Harnett County Department of Public Health

Improvement Permit

ISSUED TO: NELSON ROMERO PROPERTY LOCATION: 15 CLASSIC COVE CT. (US 401 N.)
 SUBDIVISION: CLASSIC COVE LOT # 1

Application # BRES2101-0033

Harnett County Department of Public Health Site Sketch

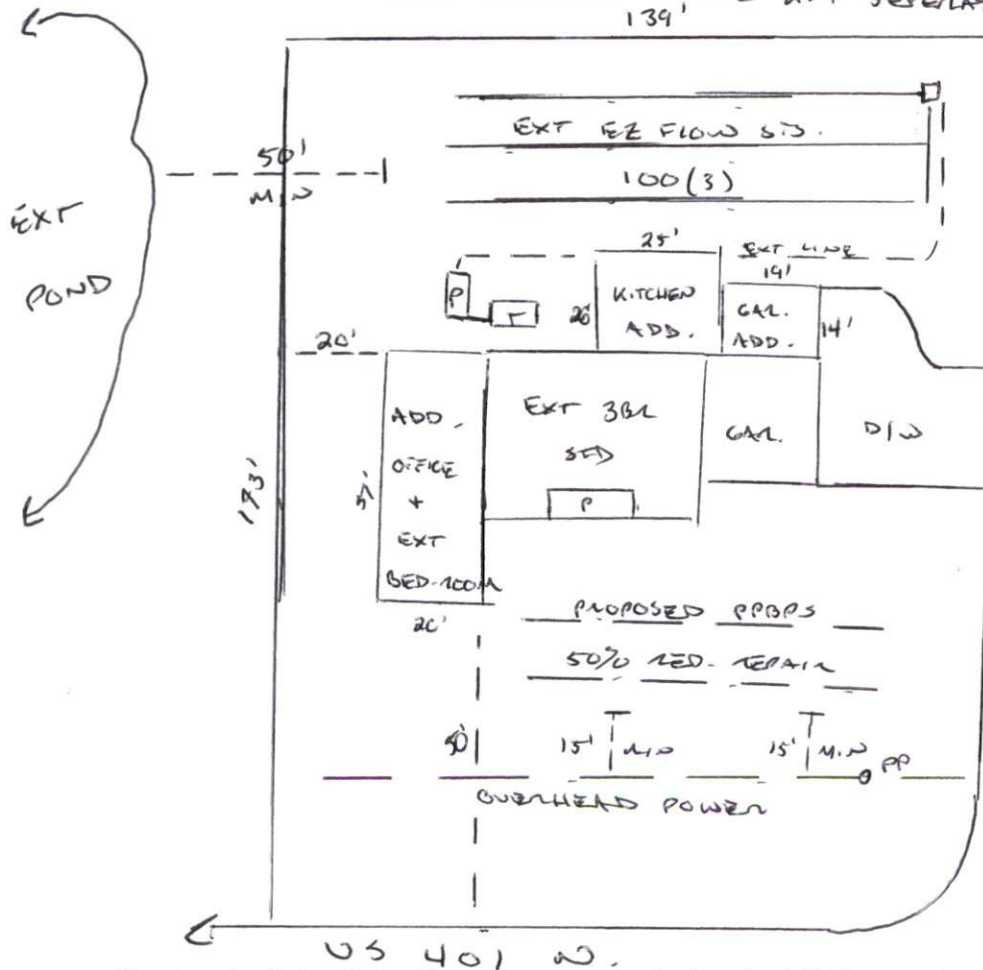
* REQUIRED SUPPLY LINE RELOCATION DUE TO NEAR ADDITION OVER
EXT LINES. SUPPLY LINE CAN BE ROUTED EXACTLY 5FT OFF NEW
ADDITION OR ROUTED TO LEFT AND ACROSS BACK

↳ IF ROUTED DOWN LEFT SIDE ENDS SHALL BE LOCATED W/ 2FT
SEPERATION AND SUPPLY LINE SHALL BE VERIFIED 5FT OFF
EXT POND. SAME 2FT SEPERATION BTL IE FLOW ON BOTTOM
139'

- * UNCOVER SEPTIC TANK
- SANITARY TEE SHALL BE VERIFIED ONSITE
- * RISERS ON TANK AND PUMP SHALL BE ADDED IF DEEPER THAN 6IN [REQUIRED]
- * INITIAL SIS. SHALL BE DEEPER THAN 6IN
- IMPORT COVER SHALL BE ADDED [WILL SHOW]
- * PROTECTIVE BARRIER SHALL BE ADDED DUE TO NEW CONSTRUCTION ONSITE [REQUIRED]

* DO NOT DRIVE OR PARK ON SEPTIC AREA [REQUIRED]
